PCN # Alternate Assembly Location for Thyristor SOT23_SOT89_SOT223 package

Product/Process Change Notice (PCN)

PCN#: ESW490-37 **Date:** Apr 13th, 2021

PCN Report

- 4.1 SOT23 Outline
---Dimensions A1, D, L, H_E are different

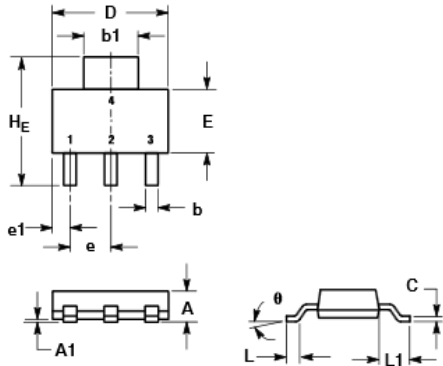
DIM	Present Sepcification			New Sepcification		
	Millimeters			Millimeters		
	Min	Nom	Max	Min	Nom	Max
A	0.89	1.03	1.17	0.89	1.03	1.17
A1	0.05	0.10	0.15	0.01	0.10	0.15
b	0.30	0.40	0.50	0.30	0.40	0.50
c	0.08	0.14	0.20	0.08	0.14	0.20
D	2.80	2.90	3.00	2.80	2.90	3.04
E	1.20	1.30	1.40	1.20	1.30	1.40
e	---	1.90	---	---	1.90	---
L	0.40	0.49	0.58	0.40	0.49	0.60
L1	0.46	0.55	0.64	0.46	0.55	0.64
H _E	2.10	2.30	2.49	2.10	2.30	2.64
θ	0°	-	10°	0°	-	10°

4.2 SOT223 Outline
 ---Dimension H_E is different.

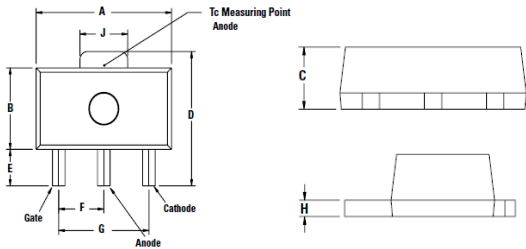
DIM	Present Sepcification			New Sepcification		
	Millimeters			Millimeters		
	Min	Nom	Max	Min	Nom	Max
A	-	-	1.80	-	-	1.80
A1	0.02	0.07	0.13	0.02	0.07	0.13
b	0.66	0.75	0.84	0.66	0.75	0.84
b1	2.90	3.00	3.10	2.90	3.00	3.10
c	0.23	0.29	0.35	0.23	0.29	0.35
D	6.60	6.60	6.71	6.30	6.60	6.71
E	3.30	3.50	3.70	3.30	3.50	3.70
e	---	2.30	---	---	2.30	---
e1	0.75	0.95	1.15	0.75	0.95	1.15
L1	1.50	1.75	2.00	1.50	1.75	2.00
H _E	6.80	7.00	7.20	6.70	7.00	7.30
θ	0°	-	10°	0°	-	10°

5.0 **Physical Differences/Changes of Reel & Tape:**

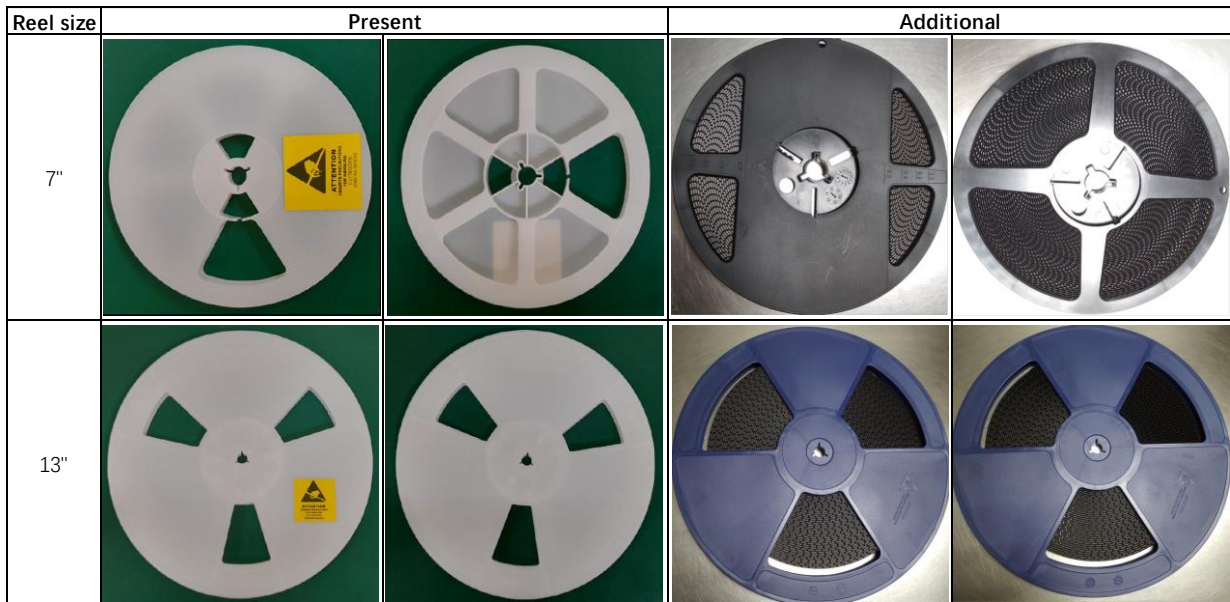
- 5.1 There are no physical differences on tape
- 5.2 There are physical differences about the reel used in 2nd subcon.

---7" reel for SOT89 & SOT223 outline, Dimension A, B, D, N are different.

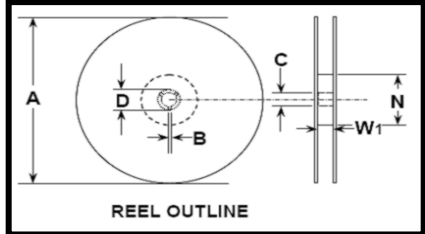
ITEM	SYMBOL	Present		New	
		VALUE (MM)	TOLERANCE (MM)	VALUE (MM)	TOLERANCE (MM)
Reel Diameter	A	180.0	±1.5	178.0	±1.0
Drive Spoke Width	B	2.3	±0.2	2.1	±0.2
Arbor Hole Diameter	C	13.0	+0.5/-0.2	13.0	+0.5/-0.2
Drive Spoke Diameter	D	21.0	+0.3 / - 0	21.2	±0.3
Hub Diameter	N	60.0	±1.0	60.0	±0.5
Reel Inner ar Hub	W1	12.4	+2.0/-0.0	12.4	+2.0/-0.0

---7" reel for SOT23 outline, Dimension A, B, D, N are different.

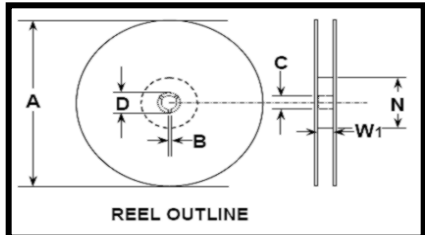
ITEM	SYMBOL	Present		New	
		VALUE (MM)	TOLERANCE (MM)	VALUE (MM)	TOLERANCE (MM)
Reel Diameter	A	180.0	±1.5	178.0	±1.0
Drive Spoke Width	B	2.3	±0.2	2.1	±0.2
Arbor Hole Diameter	C	13.0	+0.5/-0.2	13.0	+0.5/-0.2
Drive Spoke Diameter	D	21.0	+0.3 / - 0	21.2	±0.3
Hub Diameter	N	60.0	±1.0	60.0	±0.5
Reel Inner ar Hub	W1	8.4	+1.5/-0.0	8.4	+1.5/-0.0

---13" reel for SOT89 & SOT223 outline, Dimension A, B, D, N are different.

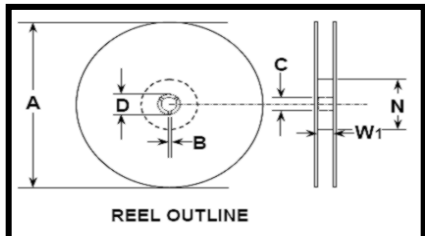
ITEM	SYMBOL	Present		New	
		VALUE (MM)	TOLERANCE (MM)	VALUE (MM)	TOLERANCE (MM)
Reel Diameter	A	330.0	±1.5	330.0	±2.0
Drive Spoke Width	B	2.2	±0.2	2.0	±0.5
Arbor Hole Diameter	C	13.0	+0.5/-0.2	13.0	+0.5/-0.2
Drive Spoke Diameter	D	21.0	+0.3 / - 0	22.0	±0.5
Hub Diameter	N	100.0	±1.5	100.0	±1.0
Reel Inner ar Hub	W1	12.4	+2.0/-0.0	12.4	+2.0/-0.0
